**PROJECT MODIFICATION
NUMBER 2**

**DREDGED SWIMMING ZONE
ALUPANG BEACH CLUB CONDOMINIUM
EAST AGANA BAY, GUAM**

**Prepared by
Pacific Basin Environmental Consultants, Inc.**

SEPTEMBER 1992

Figure 1. ABC Condominium project site showing locations of the ABC Condominium, public park, original and revised dredge areas and possible patch reef sites.

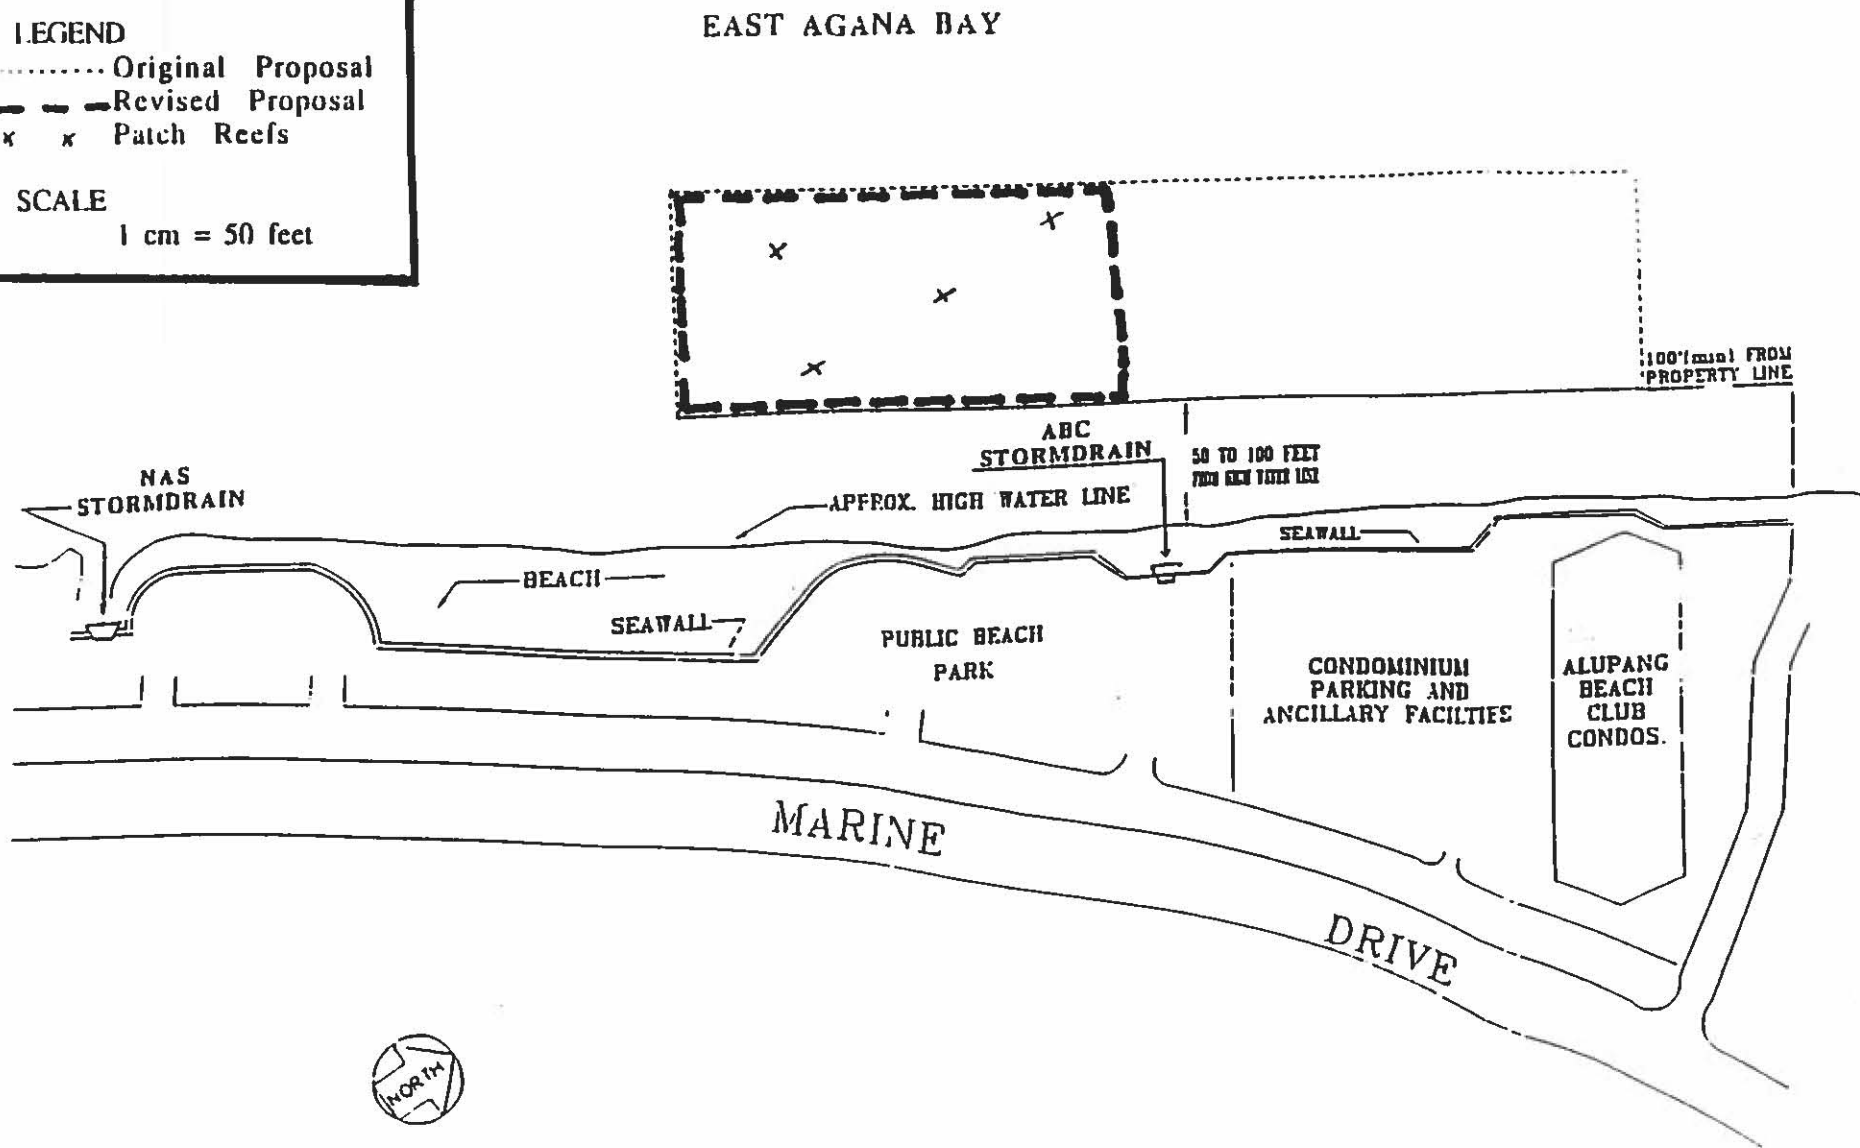
The modifications discussed in this document include changing the size and location of the proposed swim hole and adding a mitigation project. The swim hole dimensions will be decreased by more than half, to 300 x 150 feet (Figure 1). In addition it will be relocated in front of the public park next to Alupang Beach Condominium (ABC) rather than its original location partially in front of the park and partially in front of ABC. The mitigation project will provide enhancement of the swim hole as fish habitat by constructing a number of small artificial patch reefs.

The swim hole was originally located half in front of the ABC complex and half in front of the public park next door (Figure 1). The relocation of the swim hole to directly in front of the public park will clearly identify it as a public swim hole available to Guam residents and visitors using the park as well as guests and residents of the ABC complex.

The original contours (650 x 150 feet) have been changed to 300 x 150 feet (Figure 1). This results in a decrease in area from 95,500 to 45,000 square feet, or a decrease of 53 percent. Dredge volume will decrease proportionately, from 8,000 to approximately 3,760 CY. As in the original design, approximately 60 percent of the dredge material will be of beach grade sand and will be used in beach nourishment. This amounts to approximately 2,256 CY of sand available to nourish the beach. Dredge methodology and disposal will remain as proposed in the Dredge Modification #1 (1991).

Figure 2. Generalized diagram of a patch reef as proposed for the ABC swim hole, showing emergence during low tide and extensive openings available to fish and invertebrates.

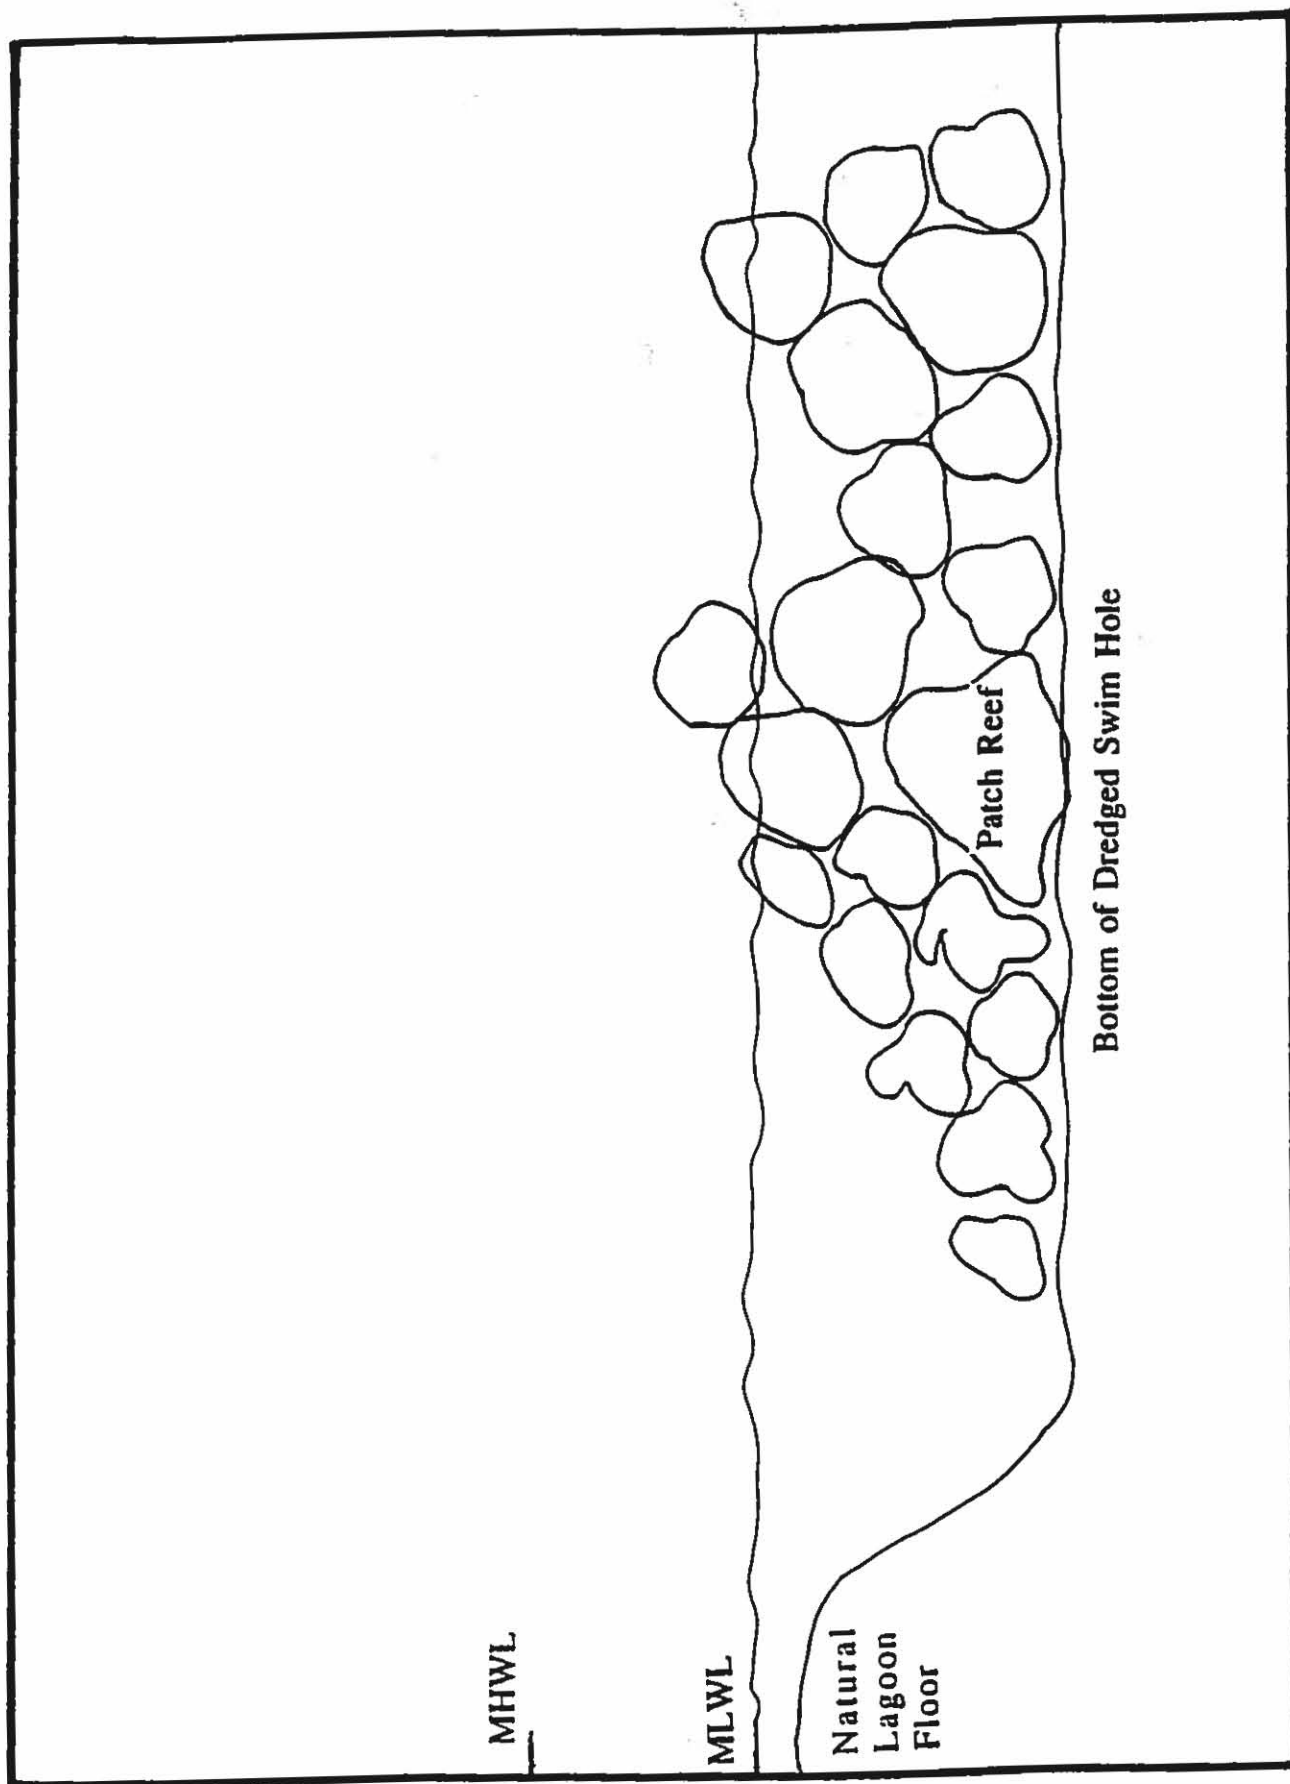
Several small patch reefs will be constructed out of large rocks and small boulders. These patch reefs will be solidly constructed to withstand storm currents and waves, and some may be visible above the water during low tides. The rocks will be irregularly piled in such a way as to create numerous nooks and crannies, passageways and other openings which will provide hiding places for fish and invertebrates of many sizes (Figure 2). Each patch reef will be irregularly shaped with a wide base and one or two rock mounds that reach near to or above the low tide water line.
